REGIONAL REVIEW NOTIFICATION

ARC REVIEW CODE: R2009021

Name of Proposal: Lake Hearn (DRI #3133)

LAKE HEARN DRI
City of Brookhaven
Natural Resources Group Review Comments

DRAWN BY SSE	CHECKED BY NCL	DATE 08/21/2020
SHEET TITLE OVERALL DRI SITE PLAN		
SHEET NUMBER C-1

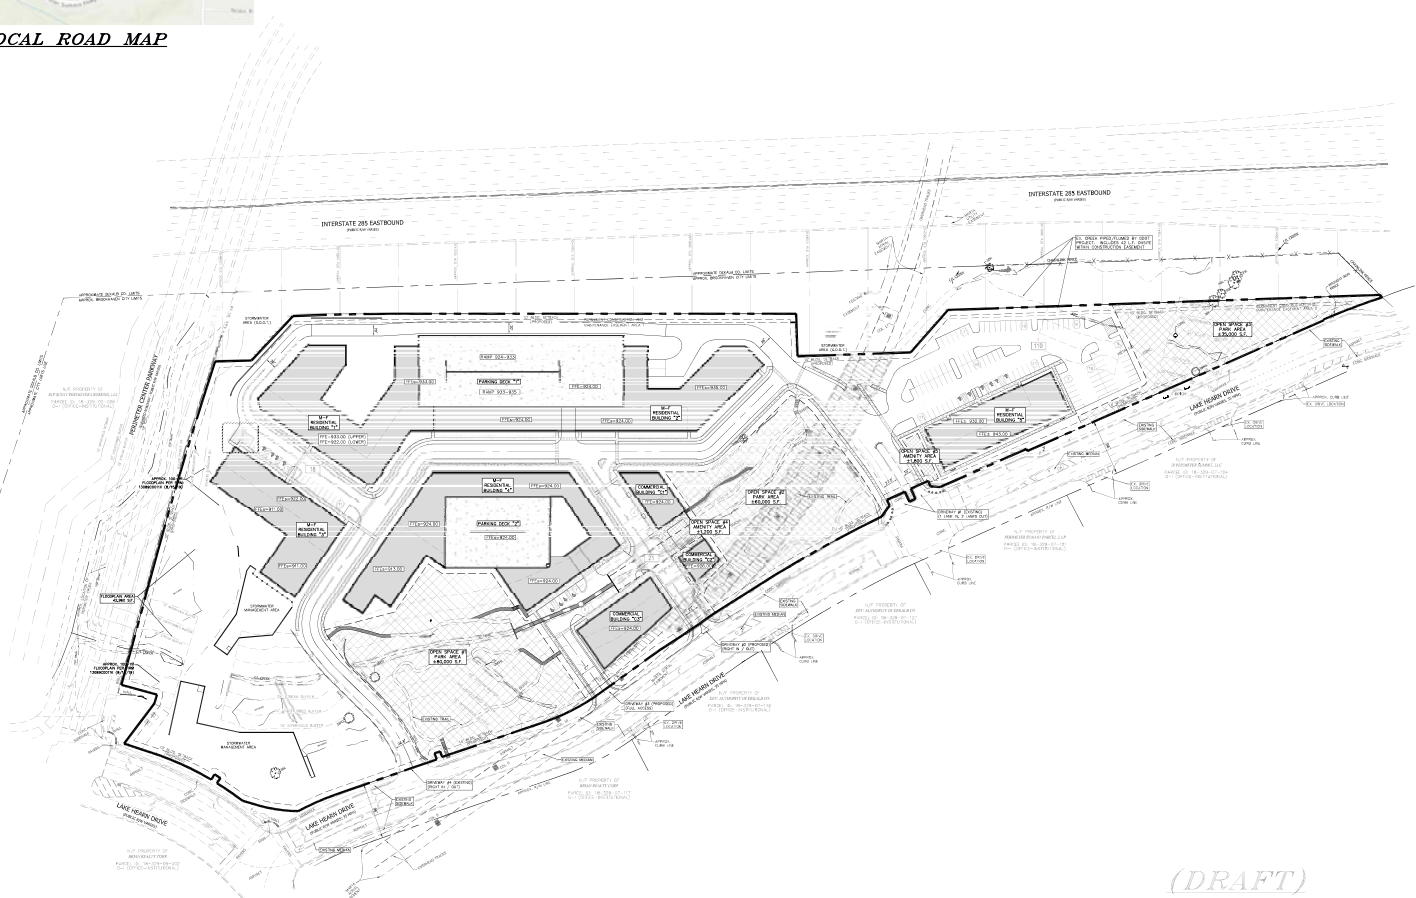
The location of this DRI is nearly equidistant between two MARTA heavy rail stations: Medical Center to the southeast and Perimeter to the north. While the site is walkable to each station in a basic linear sense, the actual conditions of the user experience vary. A potential improvement discussed during the Pre-Review meeting was creating a pedestrian access point at the southwestern corner of the site, near the intersection of Perimeter Center Parkway and Lake Hearn Drive. This will reduce the walking distance for residents, employees, and other visitors to the site to both MARTA stations, by not forcing them to first walk down Lake Hearn Drive. This will have the added benefit of making the proposed public greenspace at the southern end of the site more accessible to pedestrians coming from other locations. This was discussed at the Pre-Review meeting, but it is not indicated on the site plan submitted for review.

The proposed project is located in the Nancy Creek basin of the Peachtree Creek watershed, which in turn drains into the Chattahoochee River below the water supply intakes in the Atlanta Region. The USGS coverage for the project area shows one blue line stream running to the west of the property. The submitted site plan shows that stream as well as an unmapped tributary running along the southern portion of the property. The site plan shows the City of Brookhaven's 50-foot undisturbed stream buffer and additional 25-foot impervious setback as well as the State 25-foot erosion and sedimentation buffer along both streams. The site plan shows development within the buffers along the unmapped stream, which may require variances under the City stream buffer ordinance and the State Erosion and Sedimentation Act. Any other unmapped streams on the property may also be subject to the City's Stream Buffer Ordinance. Any waters of the state that may be on the property will also be subject to the State 25-foot erosion and sedimentation buffer requirements.
